SUNDRY NOTICES AND REPORTS ON WELLS

Moose's Tooth 29 26 33 Fed Com #111

Delaware Basin Changes to APD for Federal Well

Summary of Changes to APD Submission

Exhibit D

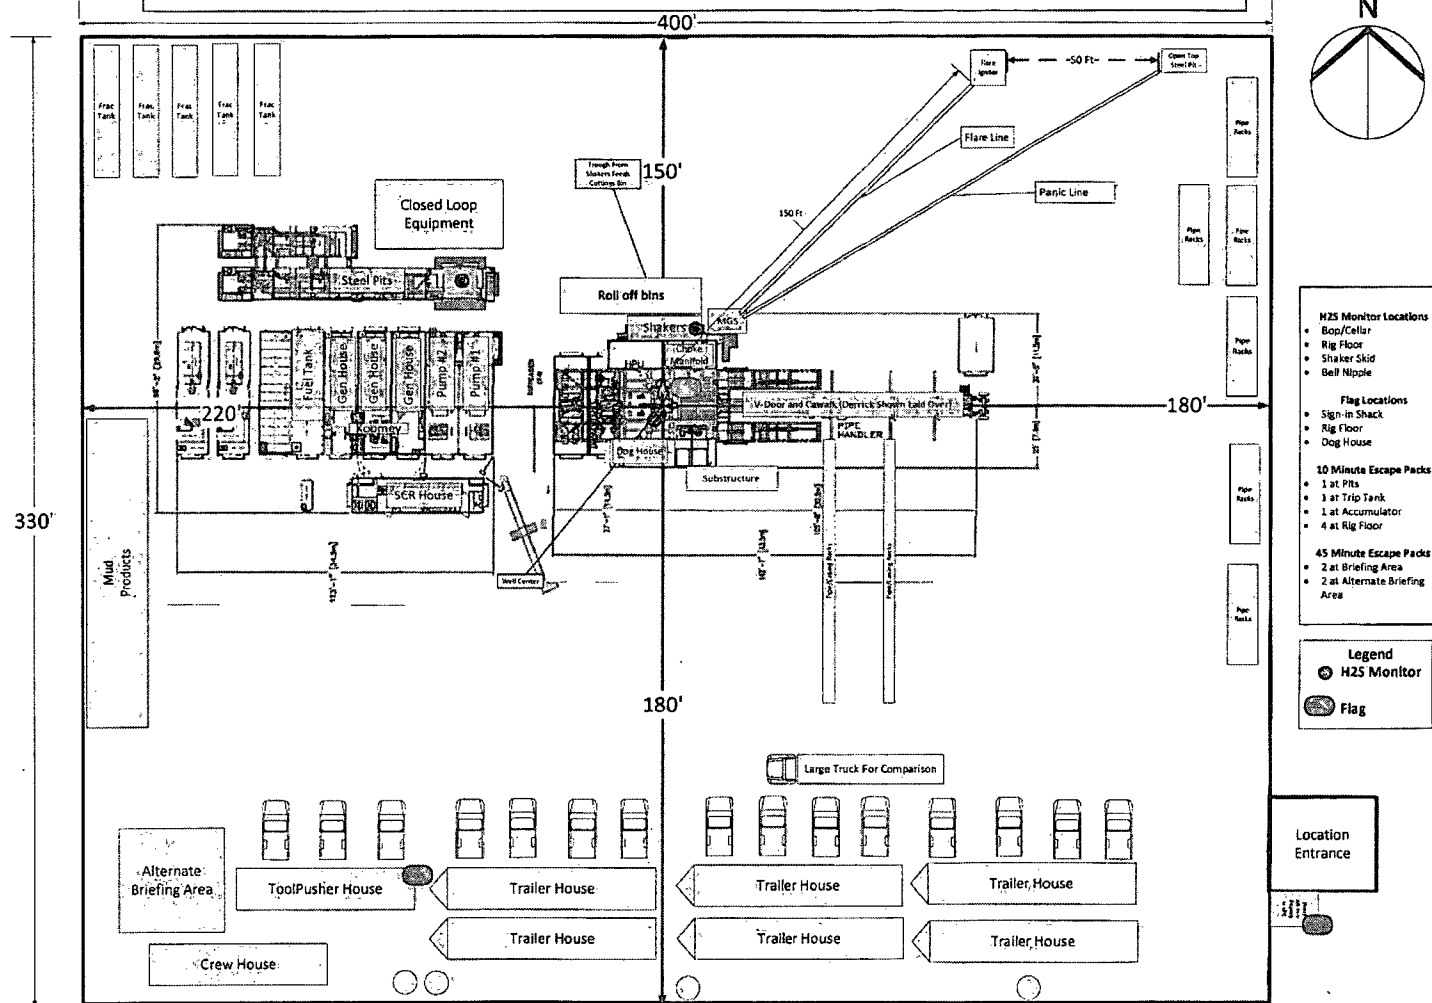
(2) Exhibit D

Summary: Ensign 153 is planned to drill the Moose's Tooth 29 26 33 Fed Com 1H well.

As Defined in APD:	As Planned on Well:
Pad layout for new build Ensign ADR 1500S rig shown.	Ensign 153 is planned to drill this well. No change to submitted pad size or well center is required.
